REMARKS

Serial No. 09/820,512
Amendment to Office Action of 8/16/2004
Annotated Sheet Showing Changes

FIG. 3

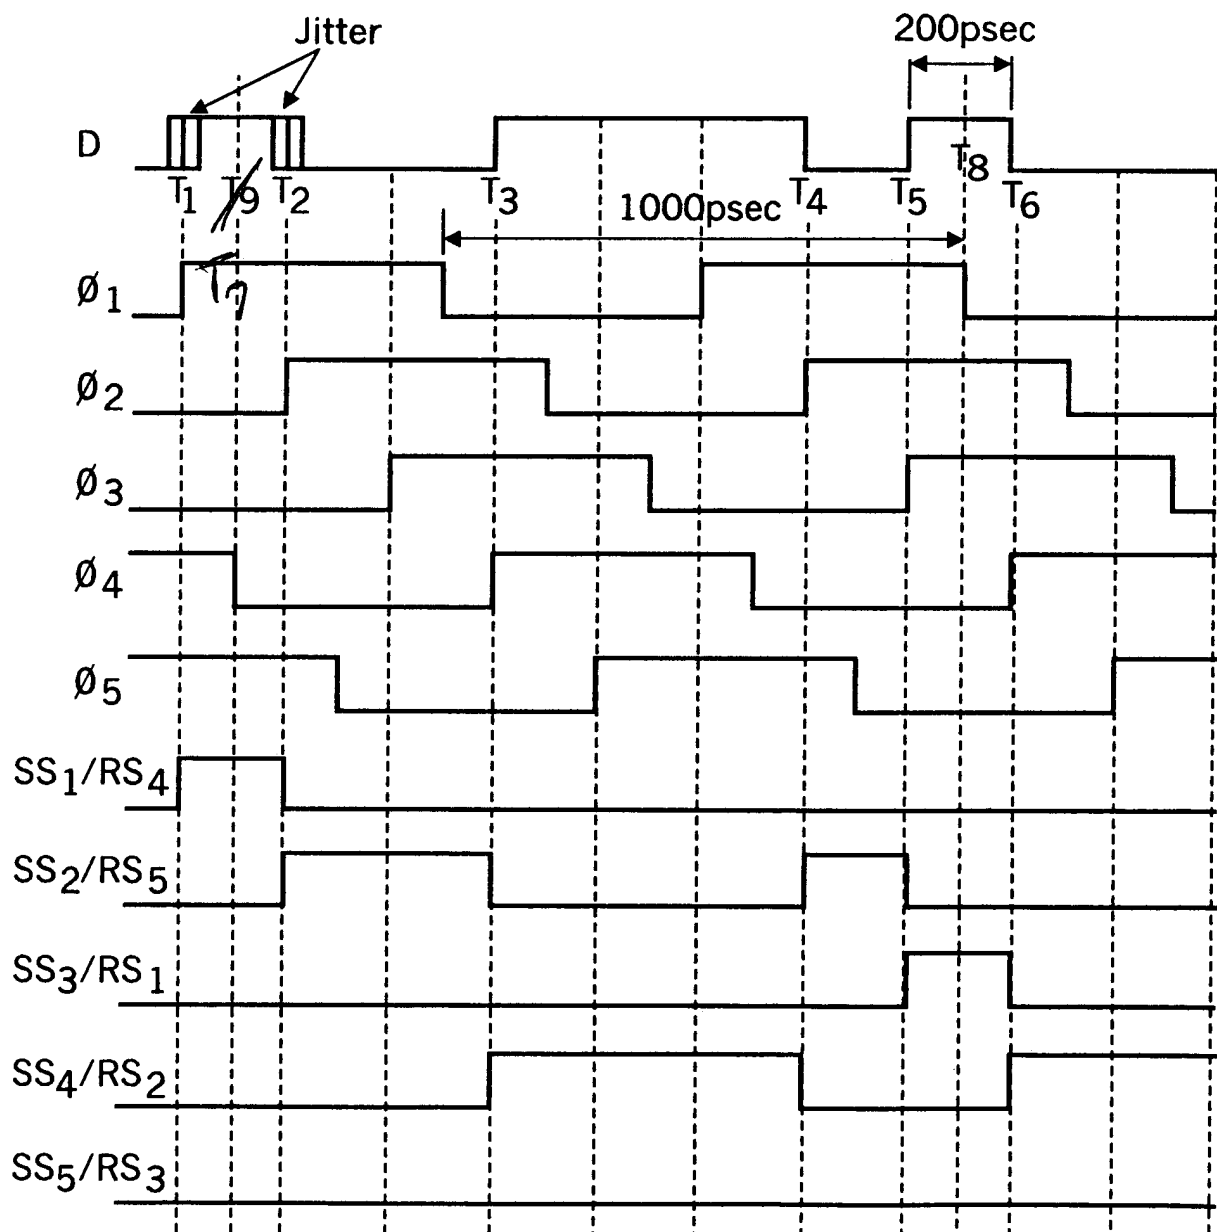
The Examiner has objected to Figure 3 because the reference sign "T9" should be "T7". The Examiner has further objected to Figure 7 because the reference sign "Out" should be "OutB." The Examiner has further objected to Figures 6A-B for missing a label for elements 601A-J. In response, Applicant has amended Figure 3 to include the appropriate reference sign "T7," Figure 7 to include the appropriate reference sign "OutB," and Figures 6A-B by adding the label of "Latch" to elements 601A-J.

Please amend Figures 3, 6A-B and 7 as shown on the attached annotated sheets. Replacement formal drawings are also attached.

FIG. 6A

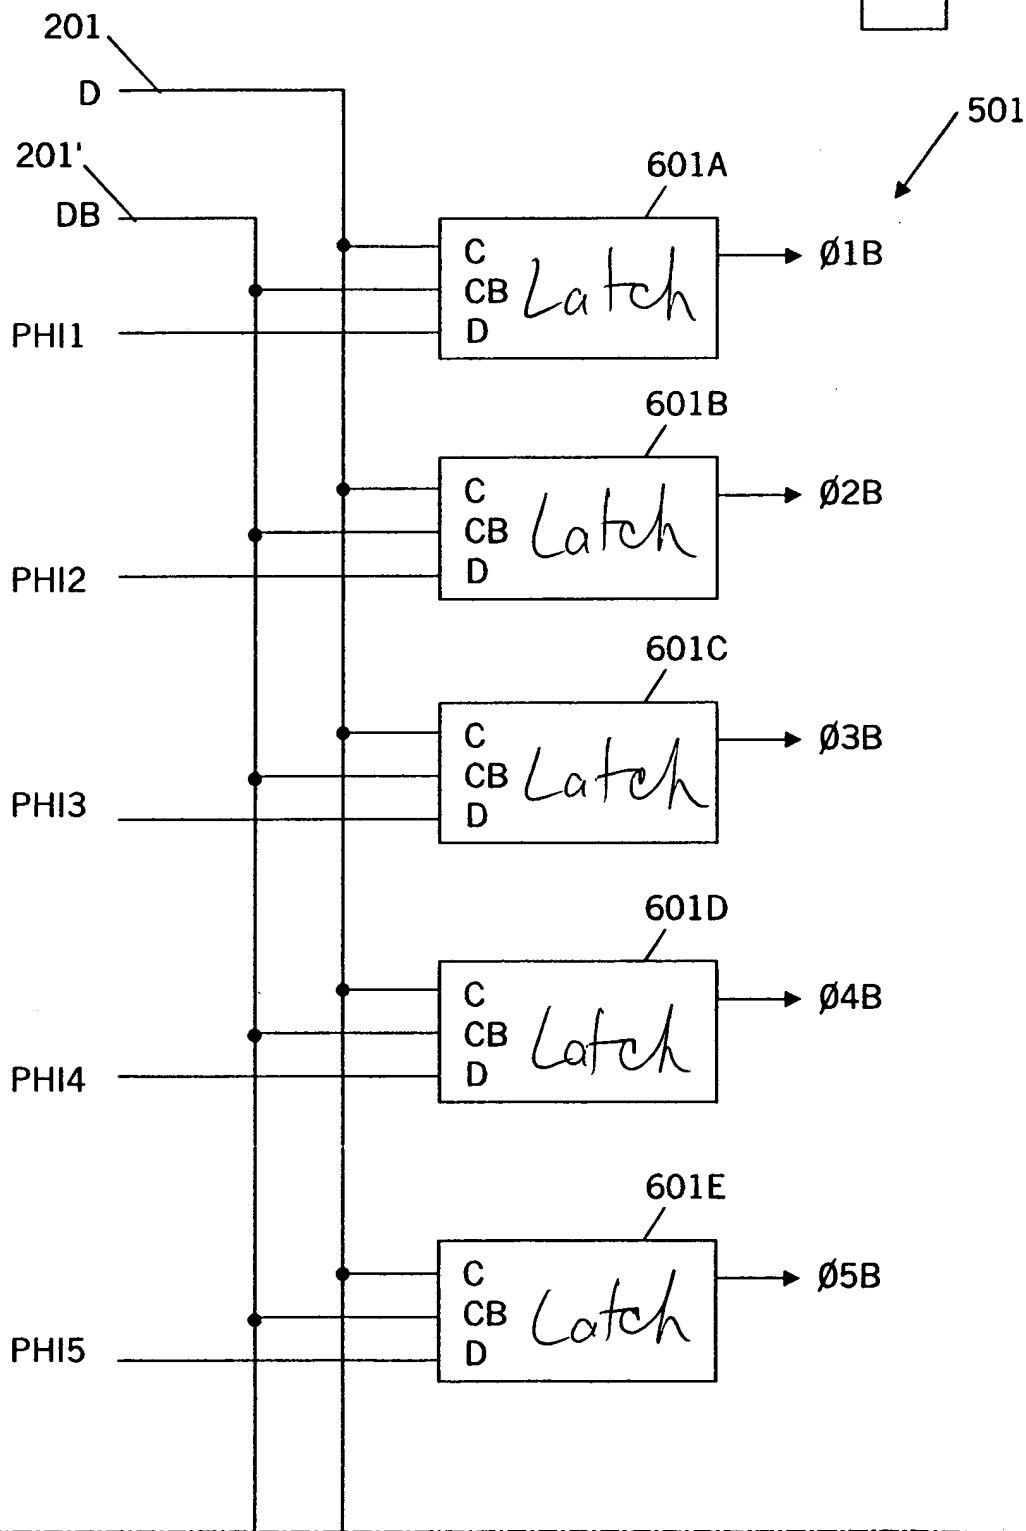
The Examiner has further objected to Figures 6A and 6B for not being discussed in the Specification. Applicant has amended the Specification to refer to Figure 6 as Figures 6A-B.
